**ADDENDUM NUMBER 1
BID NUMBER: IFB 20-011**

Exterior Wall Repair – Sumner Academy

ISSUED: June 12, 2020

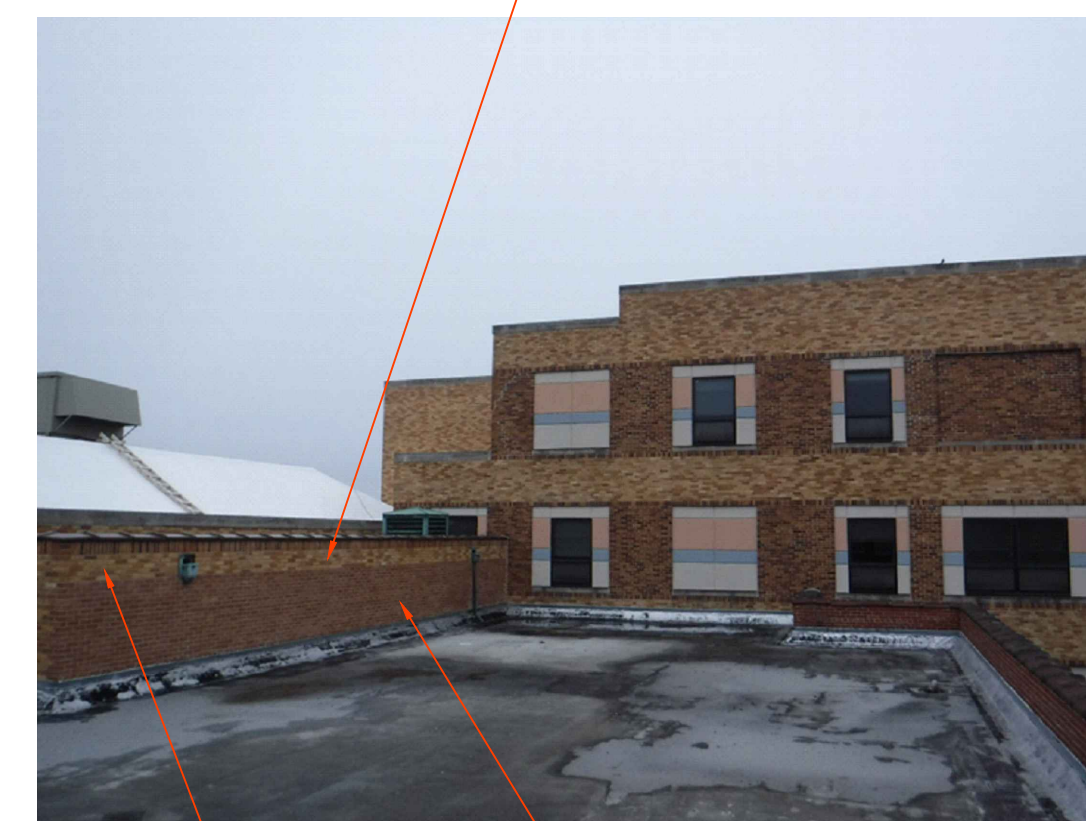
REPLACE COPING-COPING STONE AND COPING STONE-MASONRY SEALANT (3) SIDES OF STONE

EXTEND REPAIR TO CORNER

REPAIR ITEMS 7 & 8 TYPICAL (4) WALL OPENING HEADS

PHOTOGRAPH
NO SCALE

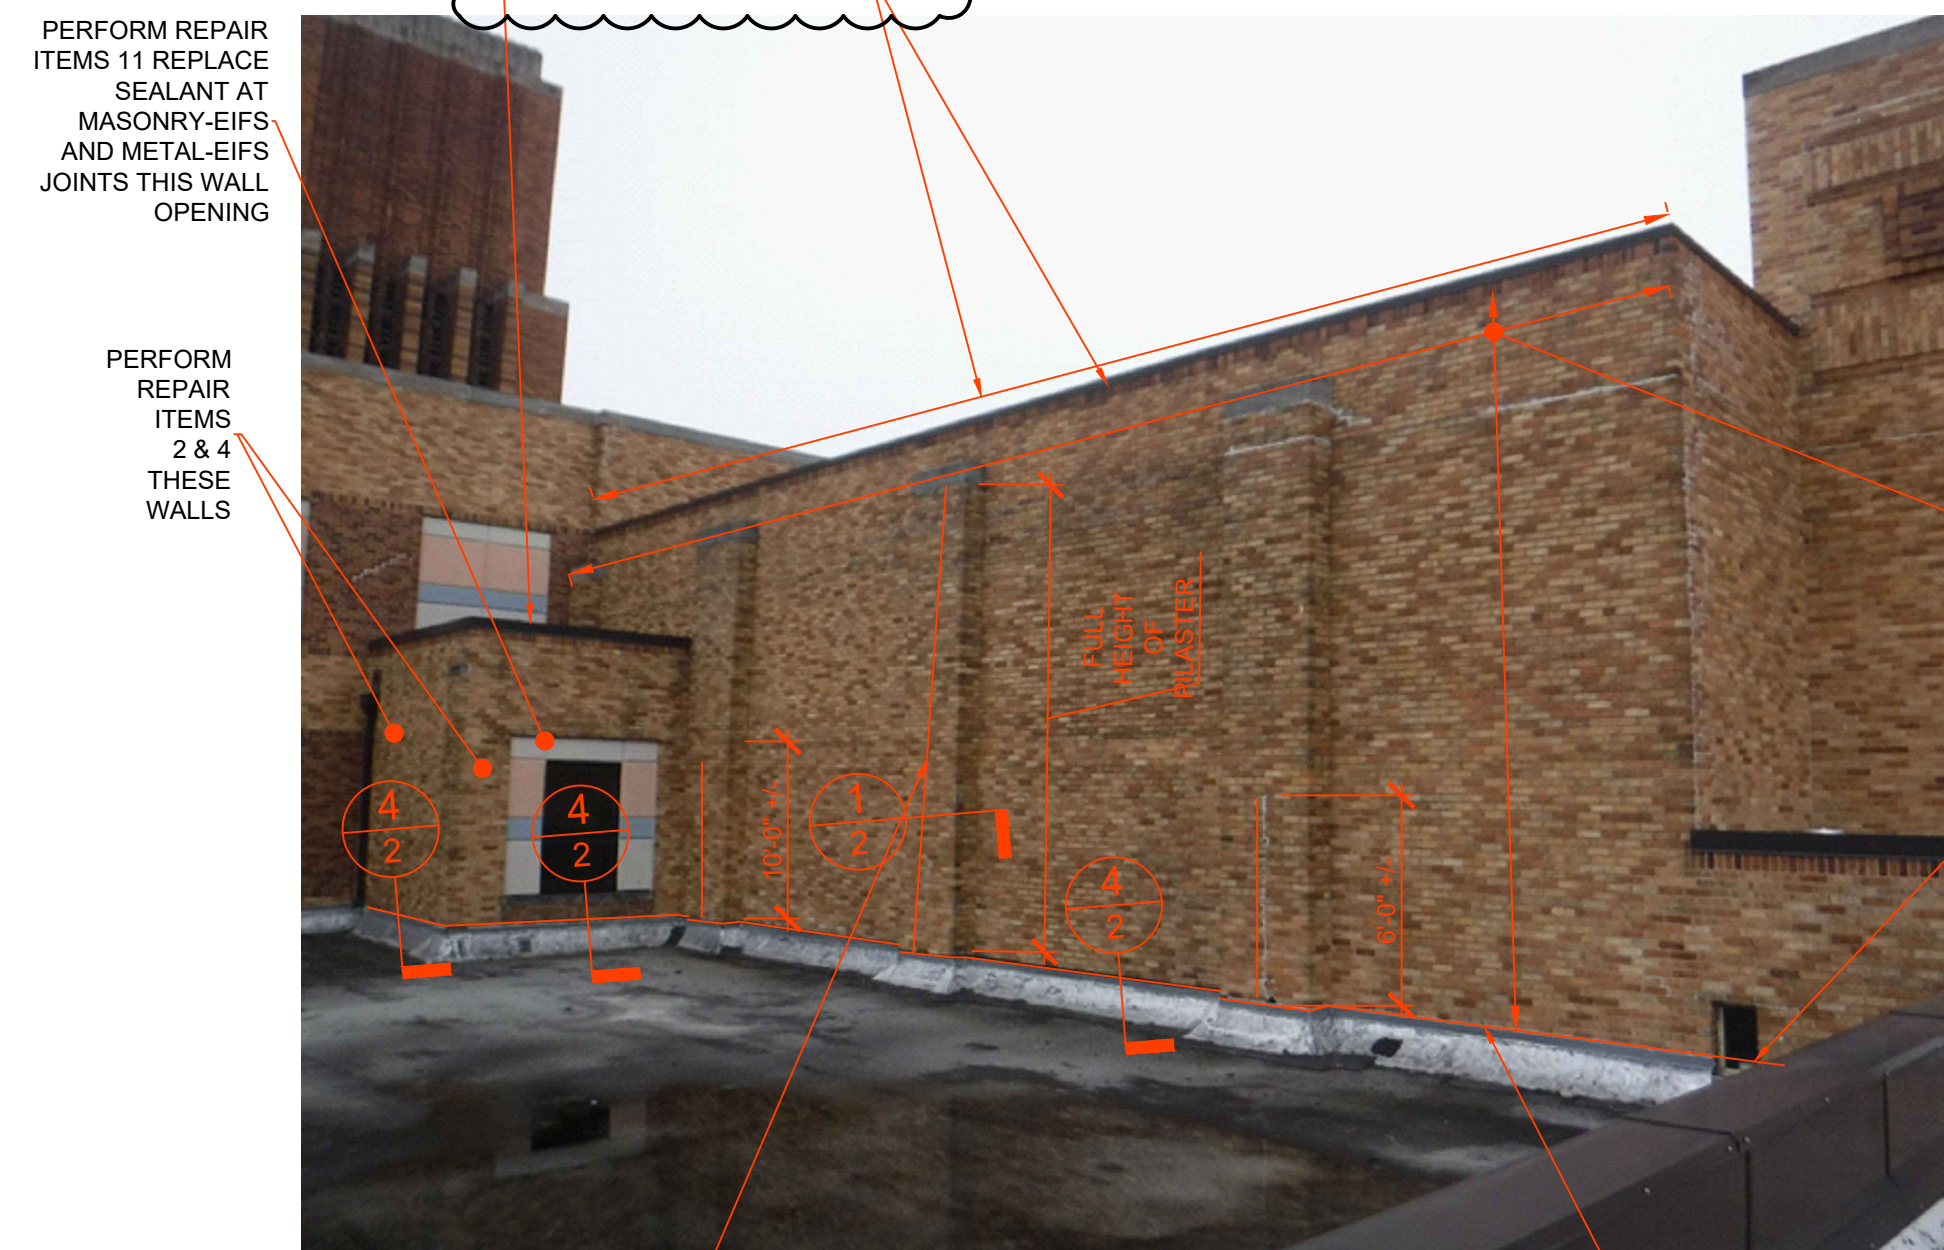
REPAIR ITEM 6 HARVEST ORIGINAL BRICK TO REPLACE CRACKED BRICK FROM THIS WALL. REPLACE BRICK REMOVED WITH BRICK UNITS CLOSELY MATCHING COLOR AND DIMENSIONS OF THE NEWER BRICK BELOW THE ORIGINAL BRICK. PROVIDE TEMPORARY SUPPORT OF THE WALL MASONRY AS ORIGINAL BRICK REMOVAL PROCEEDS. DO NOT DAMAGE ROOF MEMBRANE OR CLAY COPING UNITS.

SECTION THROUGH LINTEL 1
NOT TO SCALE REPAIR ITEM 1

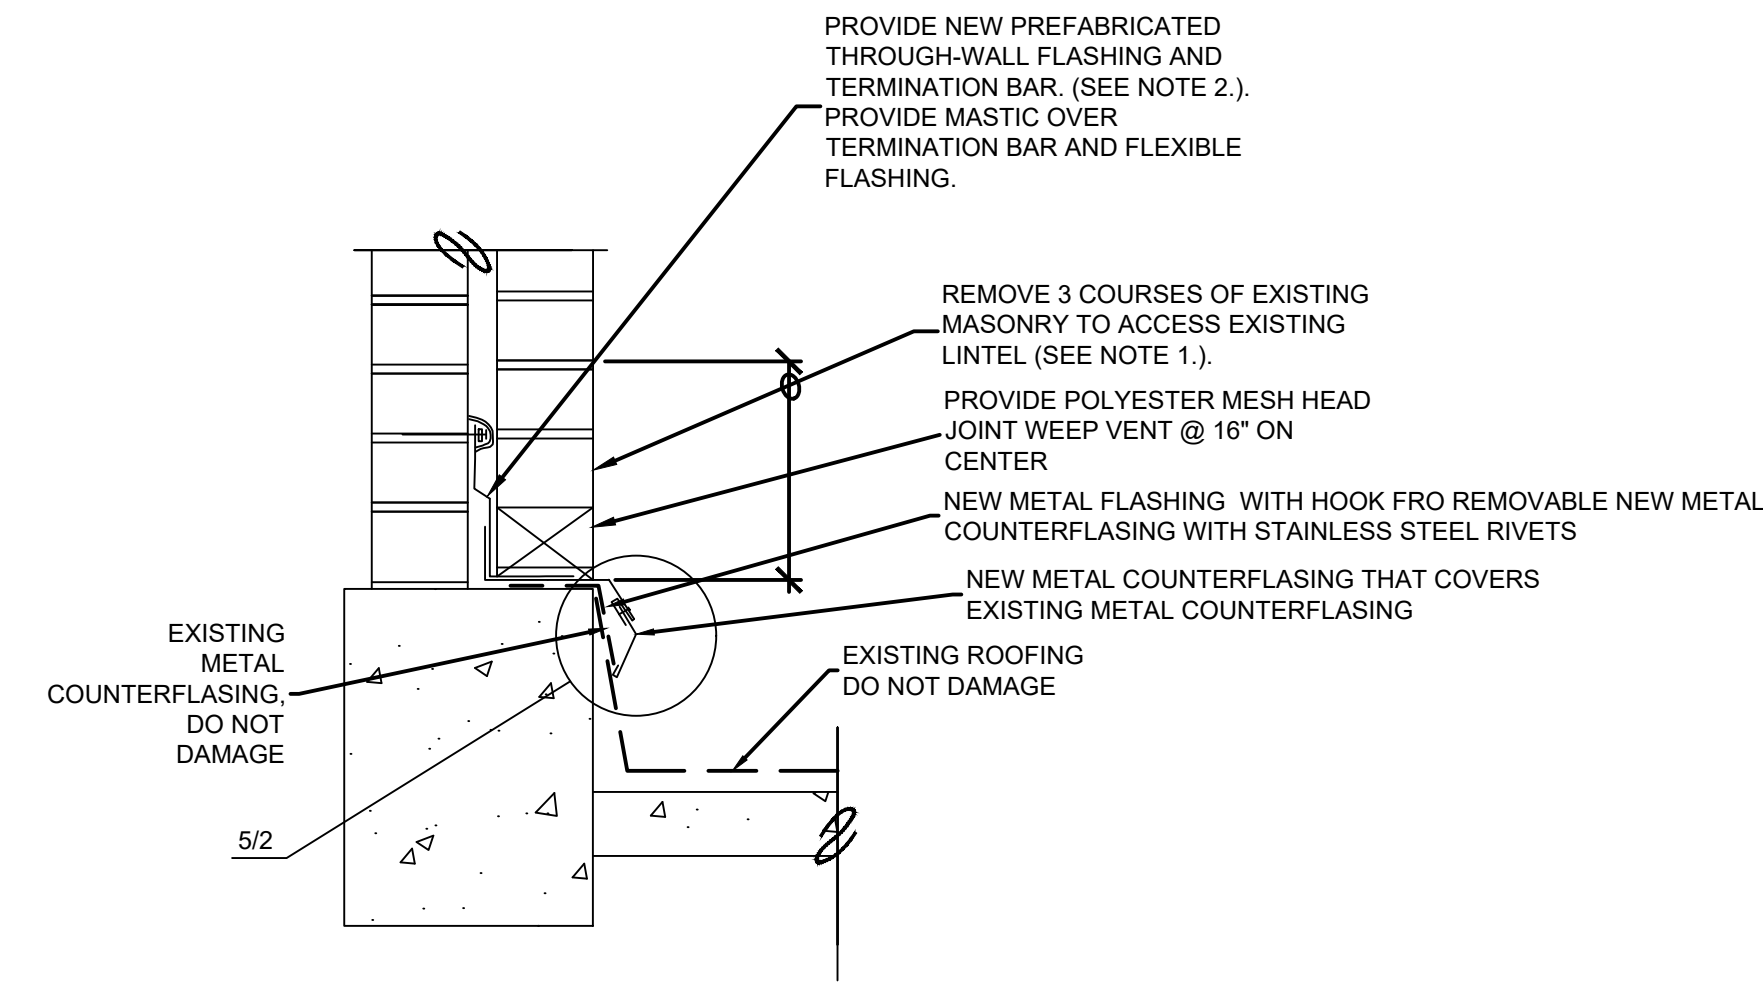
- PROVIDE THE FOLLOWING IN THE SHADED AREA.
1. REMOVE BRICK MASONRY TO EXPOSE THE METAL COLUMN WITHIN THE MASONRY.
 2. ABRASIVE BLAST CLEAN AND COAT ALL EXPOSED METAL WITHIN THE WALL REPAIR AREA.
 3. REPLACE MASONRY REMOVED TO CLOSELY MATCH EXISTING COURSING AND MORTAR COLOR AND TYPE. TOOTH-IN ALL MASONRY.
 4. EXTENT OF MASONRY REMOVED MAY EXCEED THAT SHOWN TO ACCESS NORTH FACE OF COLUMN FLANGE. REMOVE MASONRY AS REQUIRED TO EXPOSE FLANGE NORTH FACE AND FLANGE SIDES.
 5. TOOTH-IN ALL NEW MASONRY.

SECTION THROUGH SILL 4
NOT TO SCALE REPAIR ITEM 4

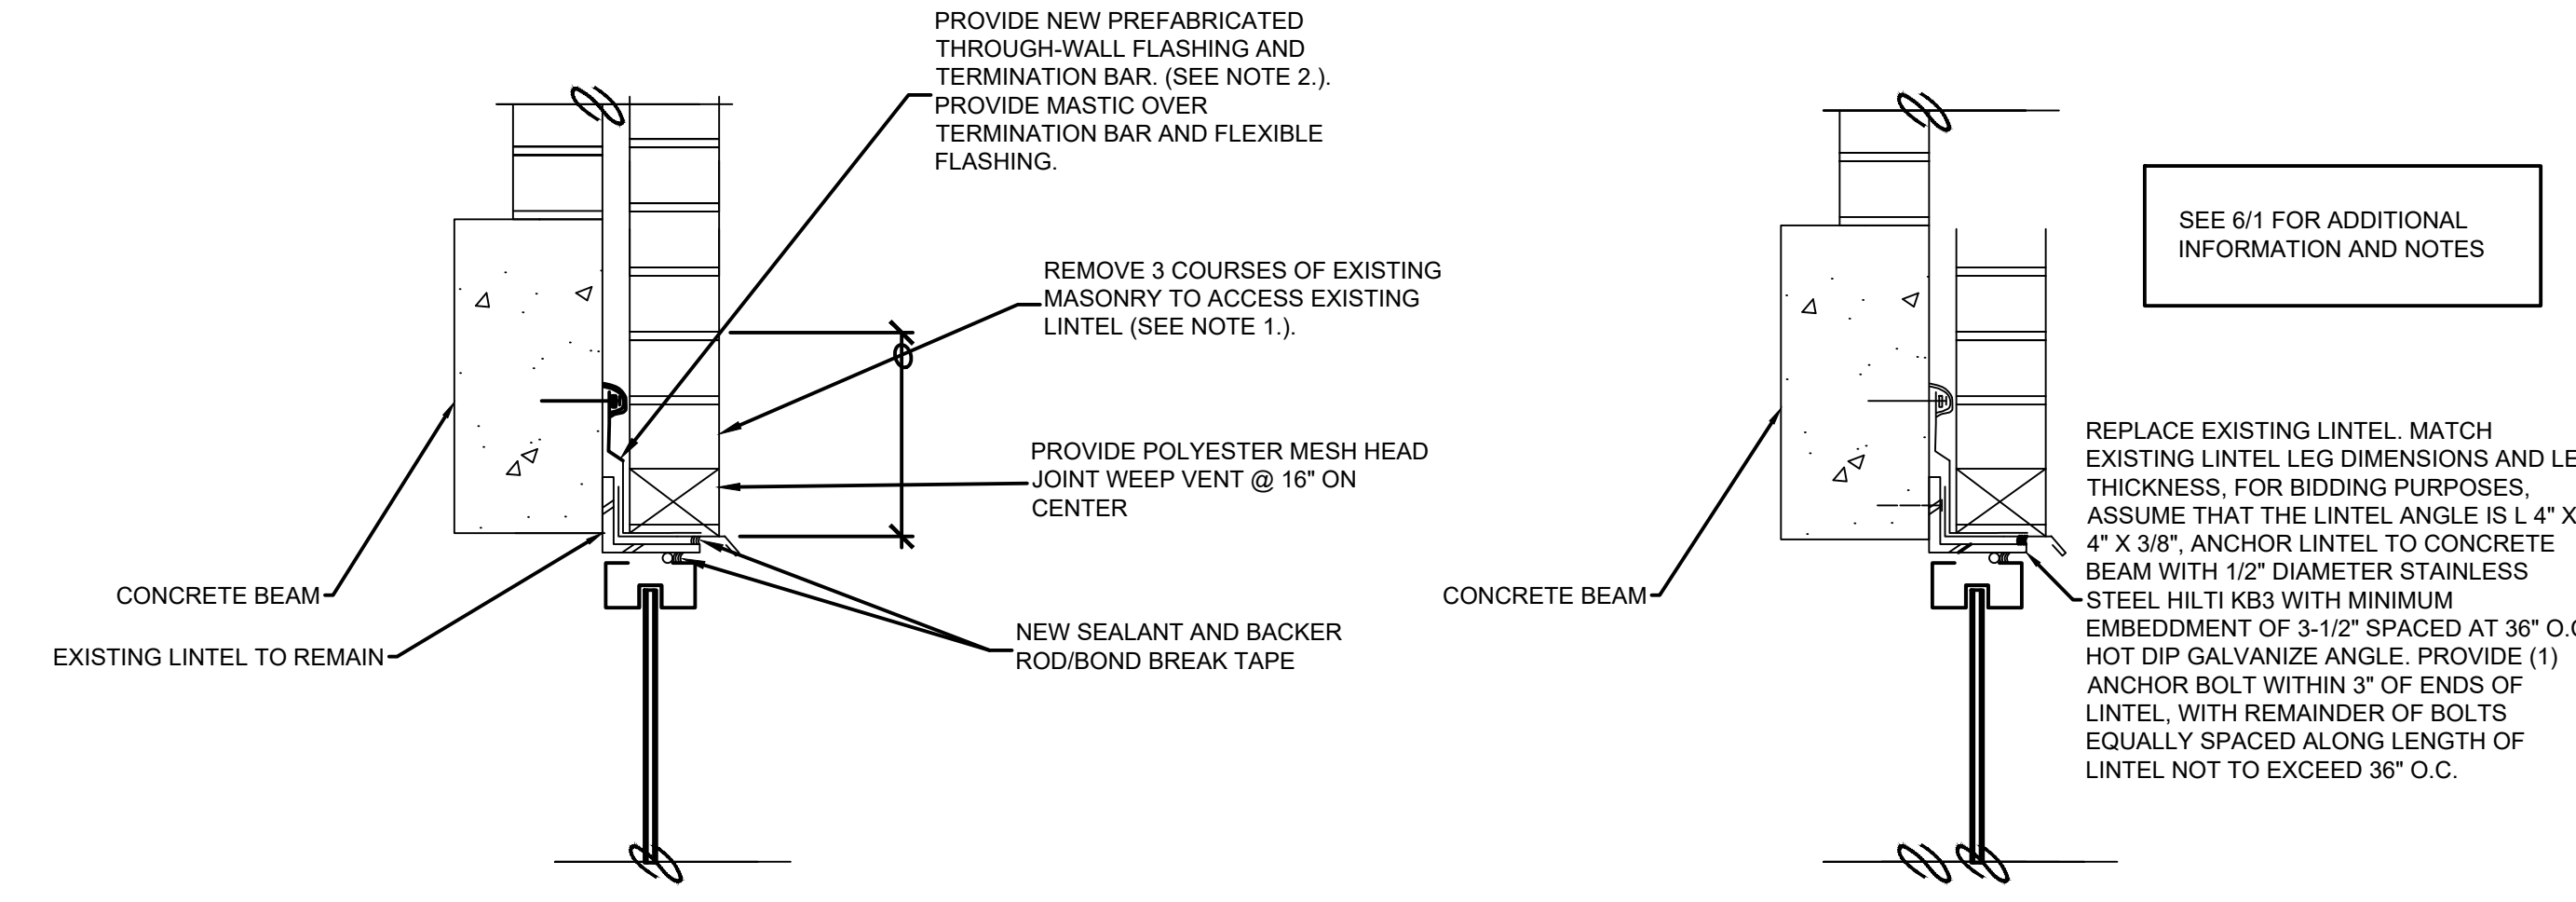
- REPAIR ITEM 4 NOTES
1. MAINTAIN STABILITY OF THE EXISTING BRICK ABOVE BRICK LINTEL REMOVAL AREAS AT ALL TIMES. PROVIDE TEMPORARY STEEL ANGLES OR OTHER MEANS TO SUPPORT EXISTING MASONRY. PROVIDE NEW BRICK AND MORTAR MASONRY TO CLOSELY MATCH THE EXISTING BRICK AND MORTAR COLOR, TEXTURE, BOND PATTERN, AND TYPE OF MORTAR JOINT. PROVIDE NEW BRICK AND MORTAR MASONRY SO THAT NEW MASONRY IS REASONABLY INDISTINGUISHABLE FROM THE EXISTING MASONRY WHEN VIEWED IN INDIRECT LIGHT FROM A DISTANCE OF AT LEAST 20 FEET.

2. INSTALL NEW PREFABRICATED FLASHING ACCORDING TO THE MANUFACTURER'S DIRECTIONS. ADHERE FLASHING TO CLEANED SURFACES ONLY. REMOVE DUST, WAX, OIL AND OTHER MATERIALS THAT MAY IMPAIR THE FLASHING ADHESION. ANCHOR TERMINATION BAR TO EXISTING CONCRETE OR MASONRY WITH STAINLESS STEEL CONCRETE 1/4" SCREWS AT 8" ON CENTER. PROVIDE PREFABRICATED END DAMS WHERE NEW THROUGH-WALL FLASHING TERMINATES AT JAMBS.

SECTION THROUGH LINTEL 2
NOT TO SCALE REPAIR ITEM 2

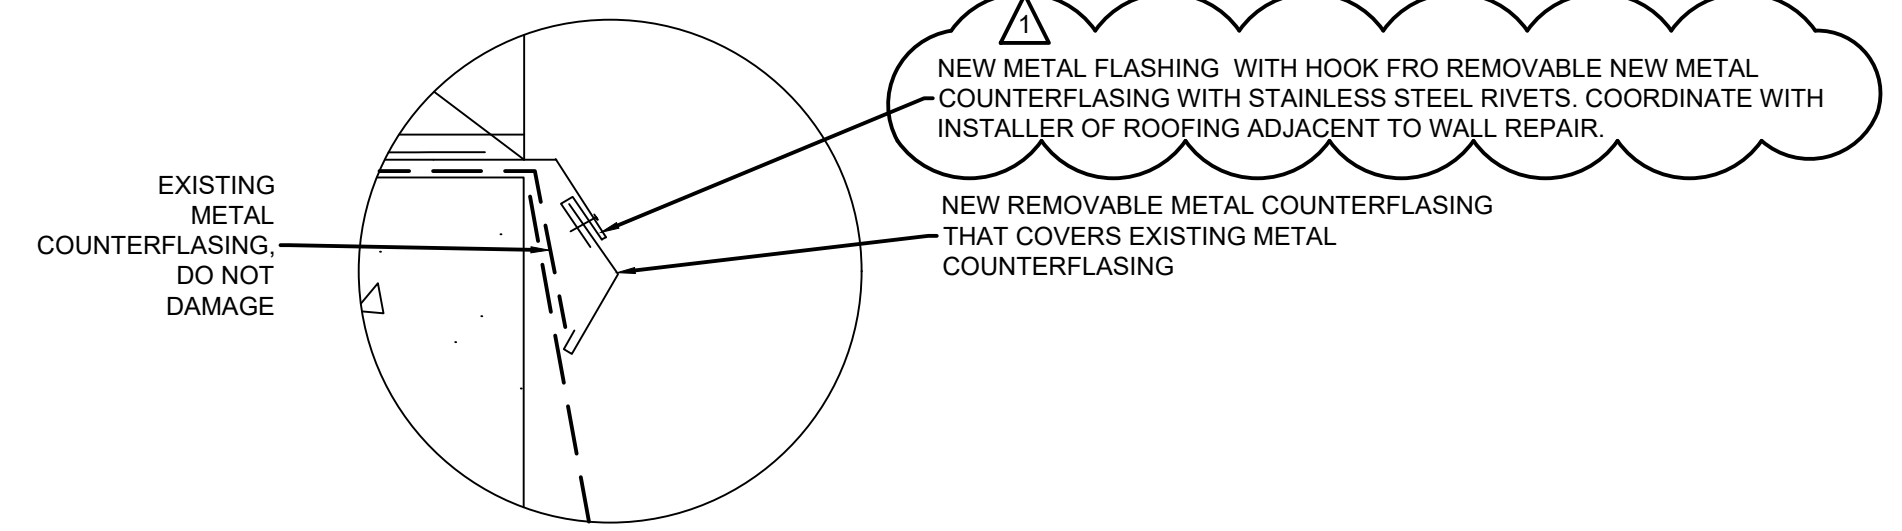
- REPAIR ITEM 2 AND 3 NOTES
1. MAINTAIN STABILITY OF THE EXISTING BRICK ABOVE BRICK LINTEL REMOVAL AREAS AT ALL TIMES. PROVIDE TEMPORARY STEEL ANGLES OR OTHER MEANS TO SUPPORT EXISTING MASONRY. PROVIDE NEW BRICK AND MORTAR MASONRY TO CLOSELY MATCH THE EXISTING BRICK AND MORTAR COLOR, TEXTURE, BOND PATTERN, AND TYPE OF MORTAR JOINT. PROVIDE NEW BRICK AND MORTAR MASONRY SO THAT NEW MASONRY IS REASONABLY INDISTINGUISHABLE FROM THE EXISTING MASONRY WHEN VIEWED IN INDIRECT LIGHT FROM A DISTANCE OF AT LEAST 20 FEET.

2. INSTALL NEW PREFABRICATED FLASHING ACCORDING TO THE MANUFACTURER'S DIRECTIONS. ADHERE FLASHING TO CLEANED SURFACES ONLY. REMOVE DUST, WAX, OIL AND OTHER MATERIALS THAT MAY IMPAIR THE FLASHING ADHESION. ANCHOR TERMINATION BAR TO EXISTING CONCRETE OR MASONRY WITH STAINLESS STEEL CONCRETE 1/4" SCREWS AT 8" ON CENTER. PROVIDE PREFABRICATED END DAMS WHERE NEW THROUGH-WALL FLASHING TERMINATES AT JAMBS.

3. MASONRY WALL SHOWN, LINTEL AT WINDOW HEAD SIMILAR.
